Re: Initial Submission Review – Kings Point South PAS 1-4 – Site Plan and Plat
Application Number: **DA-1628-06**
Case Numbers: **2022-4037-00, 2022-3063-00**

Initial Submission Review

SHEET 11 OF 33
PROJECT NO. xxx

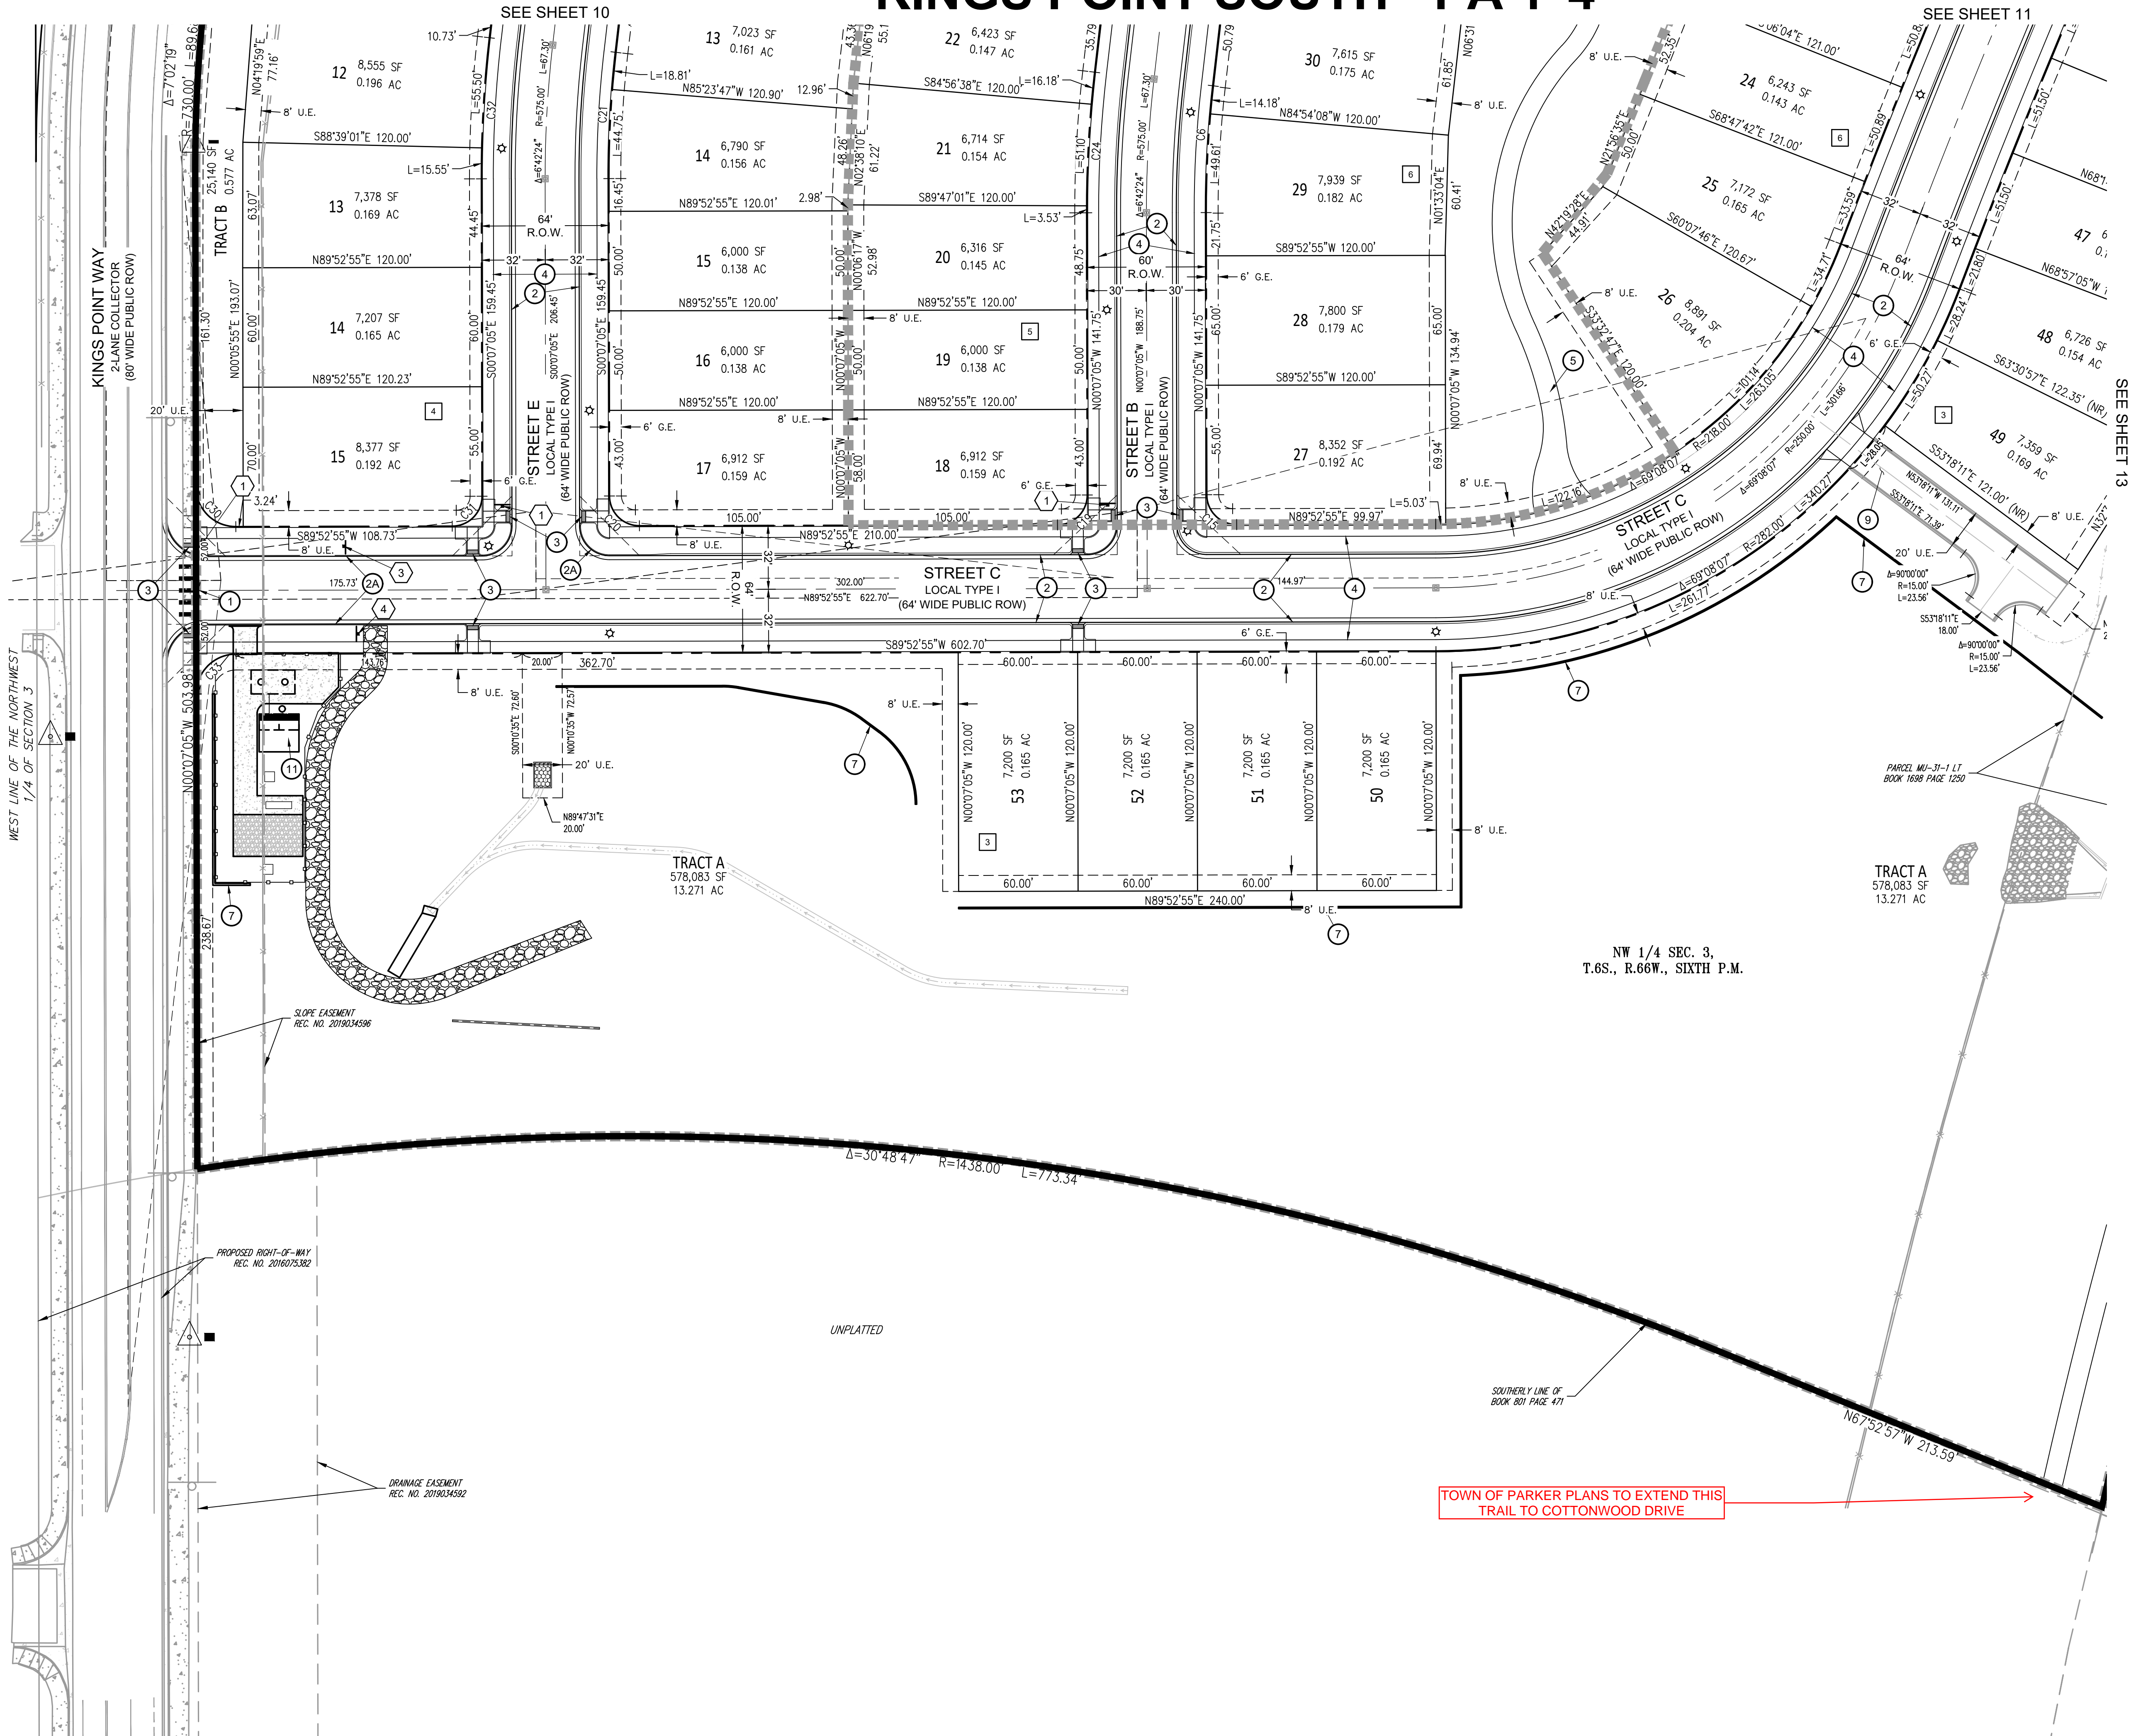
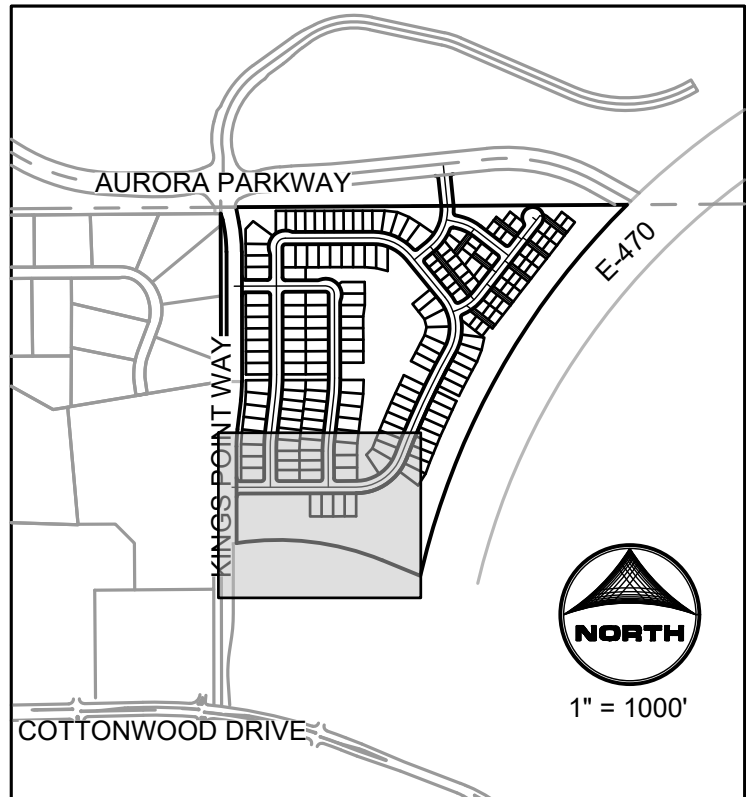
6I. The tract width must be 30 ft to break up the block length.

6J. The minimum lot frontage in the R-2 district is 50 ft.

6K. In residential developments adjacent to E-470, a minimum eight-foot-high solid sound attenuation wall must be constructed along the development's E-470 frontage. This wall should match what is proposed in the KPS Master Plan.

9T. Label what the hatch represents and if it is to remain or to be removed.

10L. Add 2B sign. [2 instances]

10M. Add 2A sign.

10N. Move off STOP sign callout.

10O. Align legs or offset a minimum 75'. Intersection should be perpendicular +/- 5 degrees.

17B. Is this a private trail? The Town of Parker has plans to extend the trail from the south end to Cottonwood Drive.

SHEET NUMBER	
SP5	
SHEET 12 OF 33	
PROJECT NO. xxx

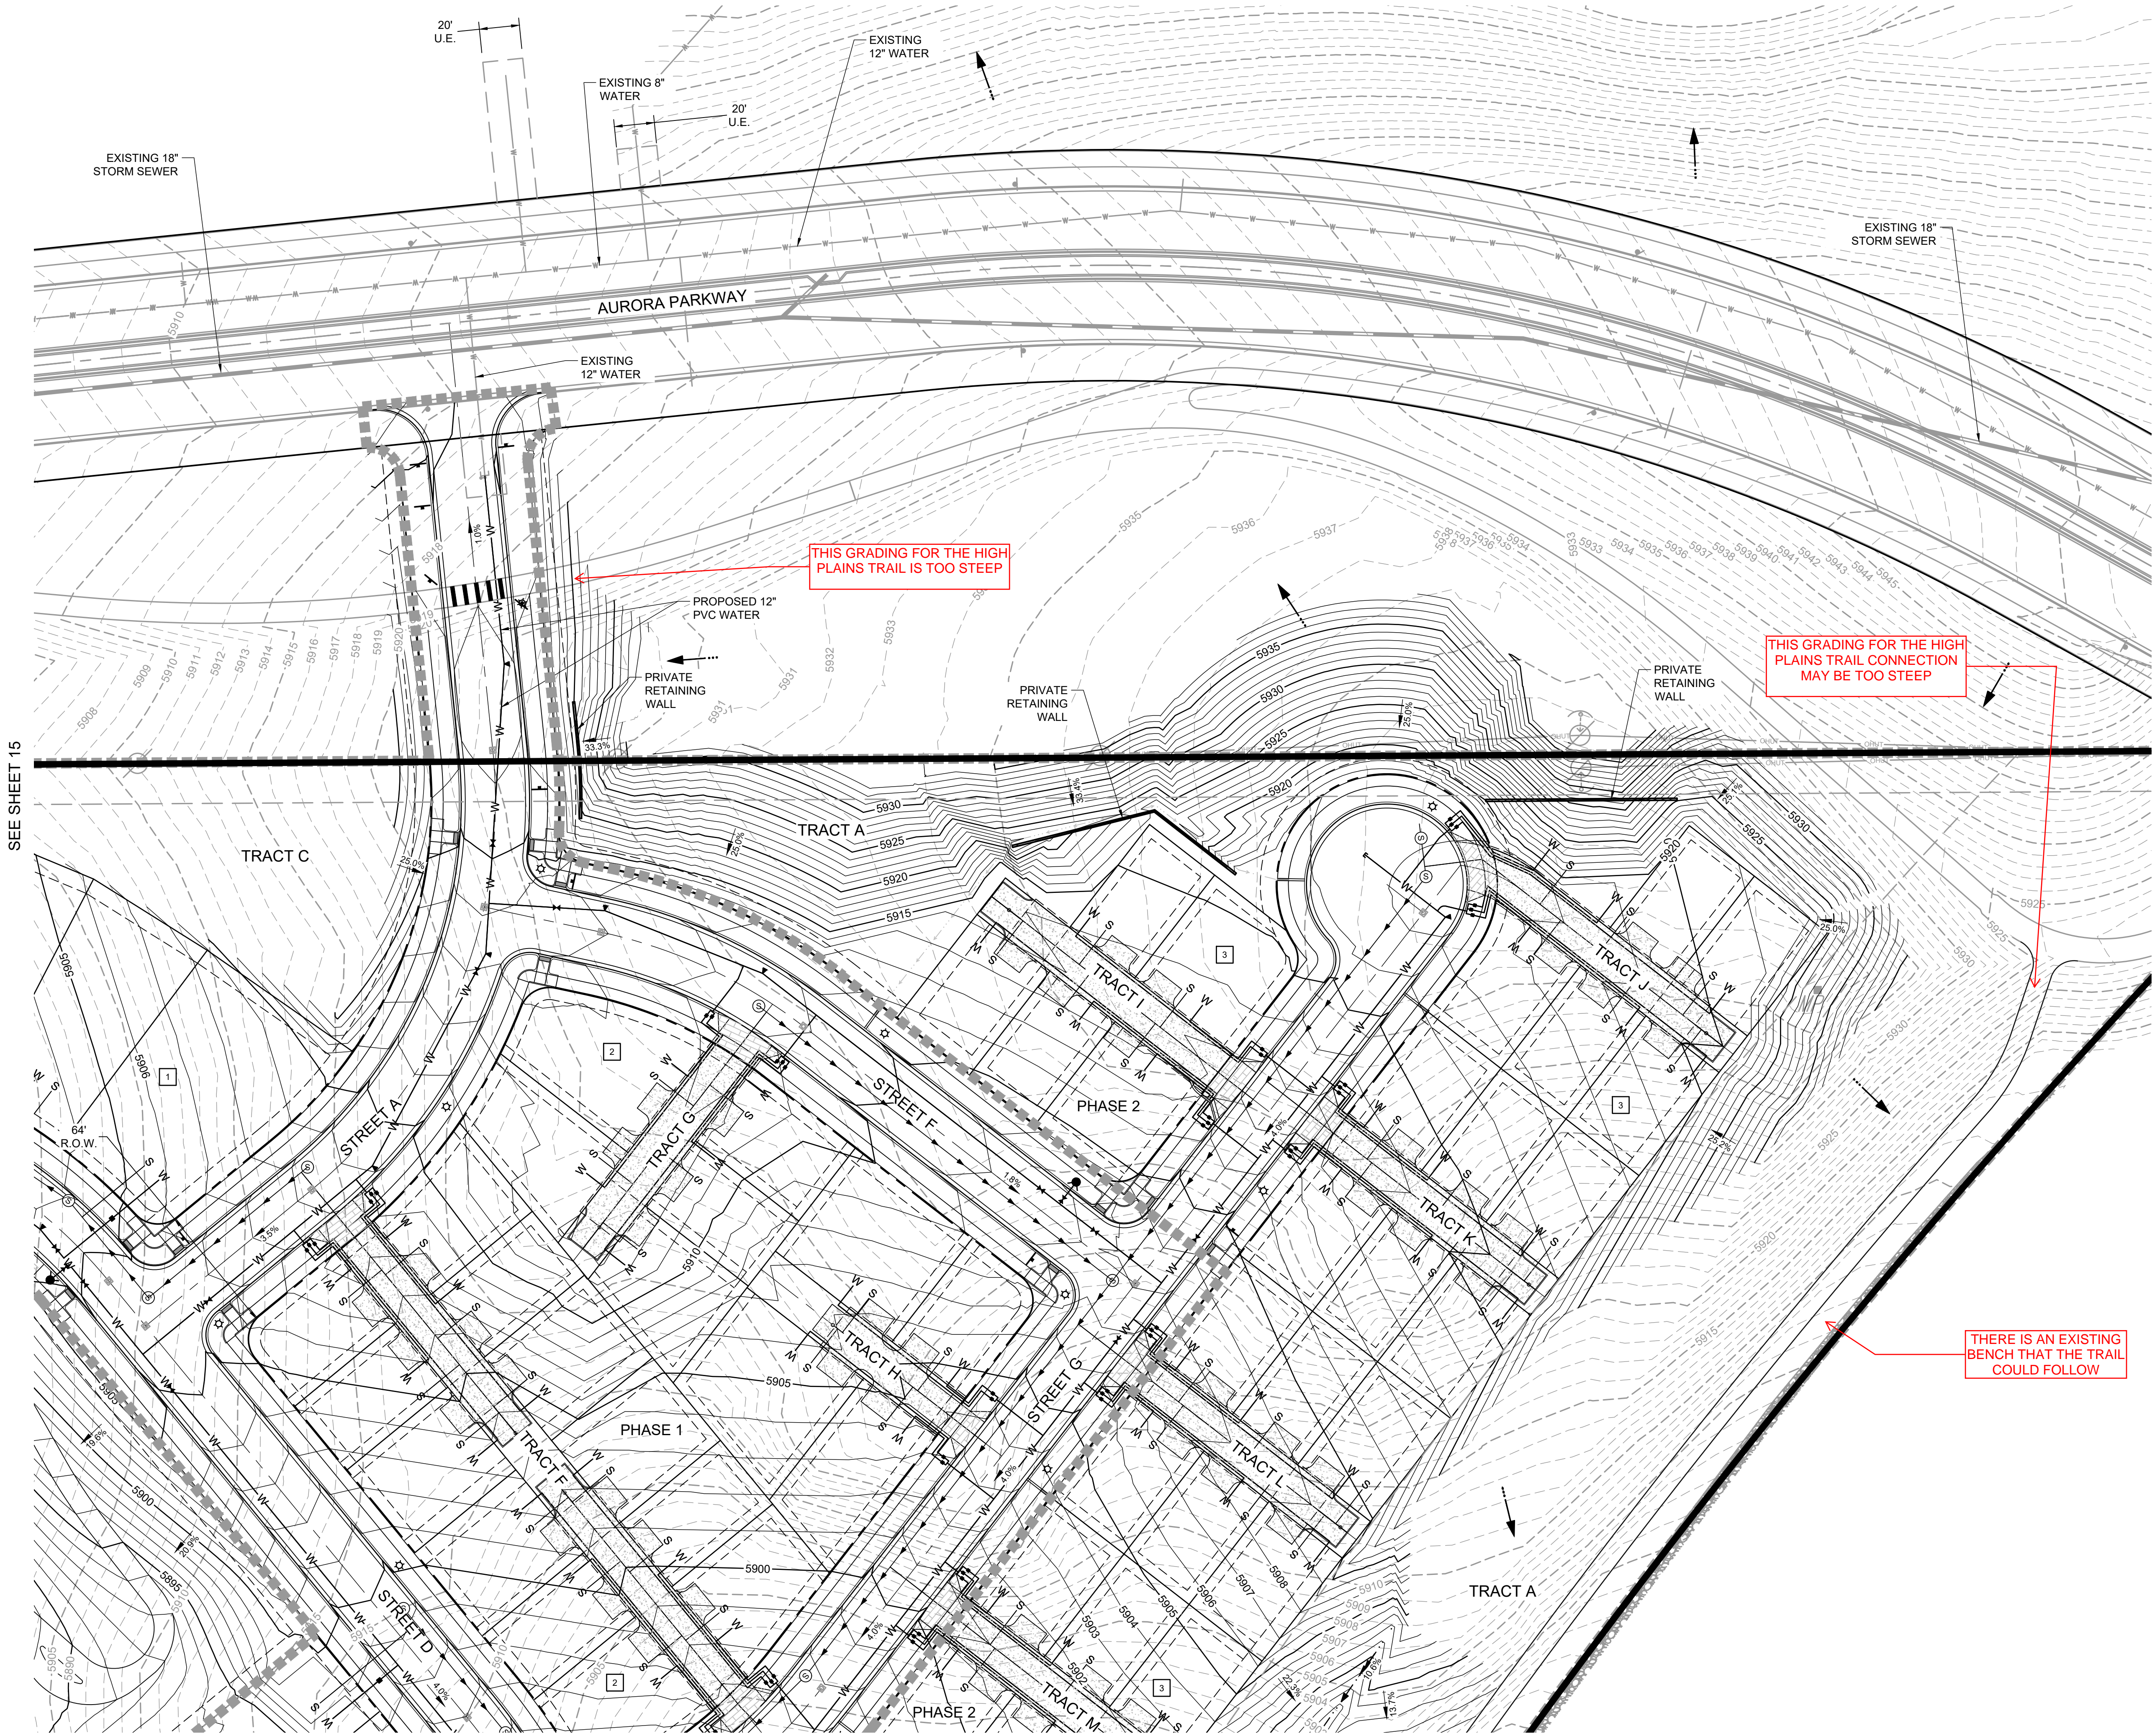
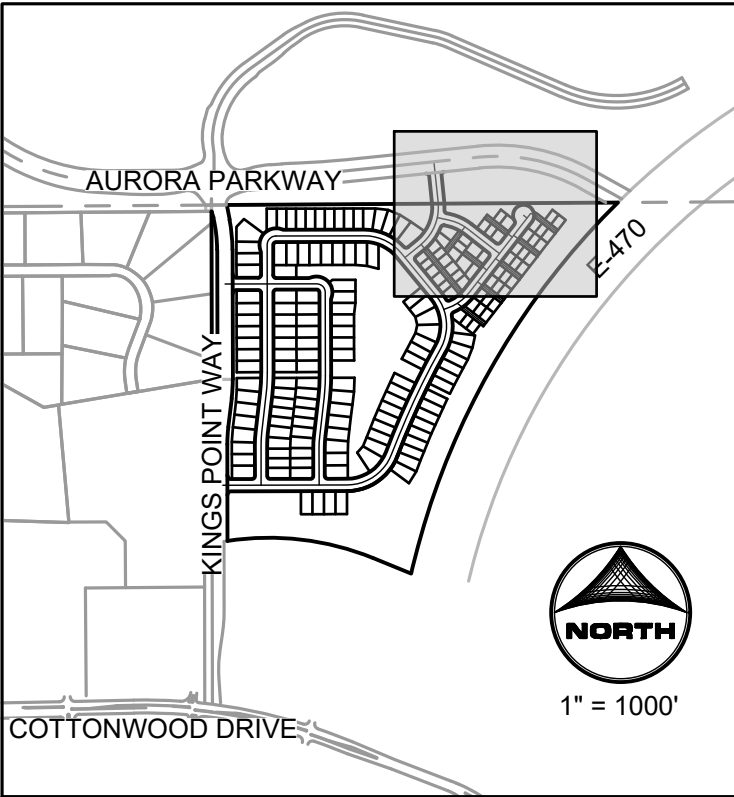
6L. What is the maximum height of the retaining wall?

9U. Show/label the required drainage easement/tract for the pond.

17C. The Town of Parker plans to extend this trail to Cottonwood Drive.
